CITY OF EAST GRAND RAPIDS

Traffic Control Order #53

Re: School Pedestrian Crossings Review
Six East Grand Rapids Schools

Figure 4F-1. Guidelines for the Installation of Pedestrian Hybrid Beacons on Low-Speed Roadways

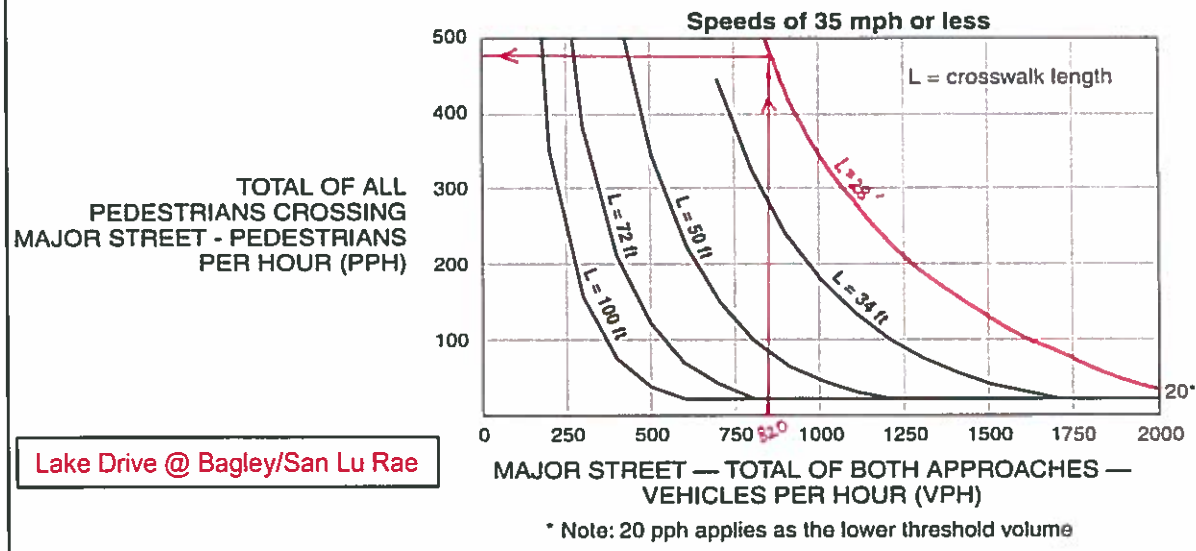
Even though those are significant pedestrian crossing volumes, they are not high enough to meet MMUTCD criteria for installation of a type of pedestrian hybrid signal. The applicable statement in Section 4F.01 of the MMUTCD for such locations notes;

Since the traffic volume on Lake Drive during the same peak hour is approximately 820 vehicles and the crossing width is 28 feet, a marked-up version of Figure 4F-1 on the next page indicates that the total pedestrian crossing volume across Lake Drive at this intersection would need to be over 400 pedestrians to meet the criteria for installing such a signal. Therefore, the combination of the peak pedestrian volumes, Lake Drive traffic volumes, and the crossing distance are easily below the required threshold for installing a pedestrian related signal.

In addition, flashing beacon type warning signs are typically used at locations that cross a multi-lane street and/or one with higher speeds than this location, and/or at mid-block locations where crossings may not be expected. Based upon the above criteria and the low crash history at this location over the past four years (average of two to three crashes per year with no pedestrian-related crashes), it does not appear that this crossing warrants the addition of a pedestrian actuated flashing beacons.

Improvement Recommendations: none other than ongoing oversight and maintenance.

Figure 4F-1. Guidelines for the Installation of Pedestrian Hybrid Beacons on Low-Speed Roadways

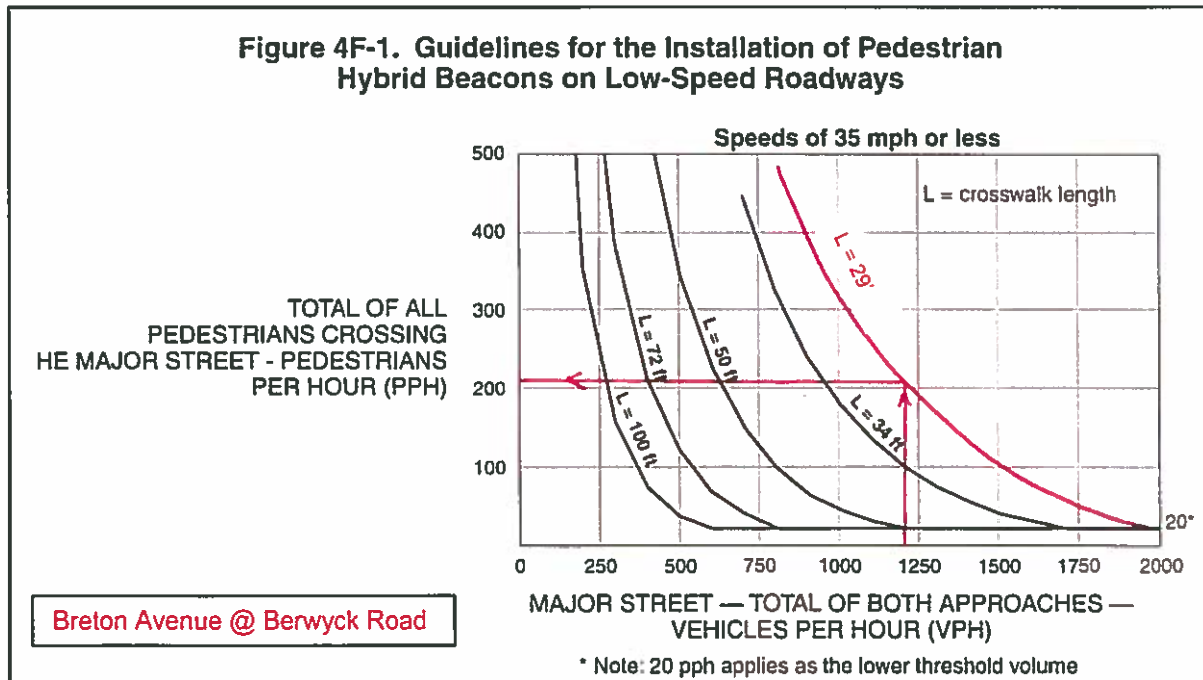
As noted for other school locations, the school crossing on Breton Avenue at Berwyck Road was recently upgraded to include newer advance warning signs and applicable signs and advisory plates at the crosswalk itself. Pedestrian counts at this location taken in May 2018 indicate that approximately four pedestrians use the crossing during the morning peak hour and approximately nine students use the crossing during the afternoon school peak. Even with the 1,200+ peak-hour traffic volume on Breton Avenue in this area during the afternoon school peak, the short crossing distance of approximately 29 feet combined with the very low crossing volume does not meet pedestrian thresholds to warrant a signal or warning beacon as shown on the marked-up version of Figure 4F-1 below.

There are two related items of note: currently there is an object warning sign (OM3-R) mounted on the southbound pedestrian crossing sign post as can be seen in the photo on the previous page. Since there is no bump out in this direction and apparently no other adjacent object, it brings in the question the need for the object sign.

There is also an existing advance school crossing sign and a low-mounted beacon on Breton Avenue facing south located just north of Berwyck Road. This doesn't appear to follow current standards either in location or design, although we suspect it was placed there as a general warning to drivers that there are school children in the area.

- Consider removing the object warning sign on the southbound side of Breton Avenue at the crosswalk at Berwyck Road since no obstruction is evident at this location.
- Confirm the rationale and need for existing advance school crossing sign and beacon located on Breton Avenue just north of Berwyck Road; if none, remove.
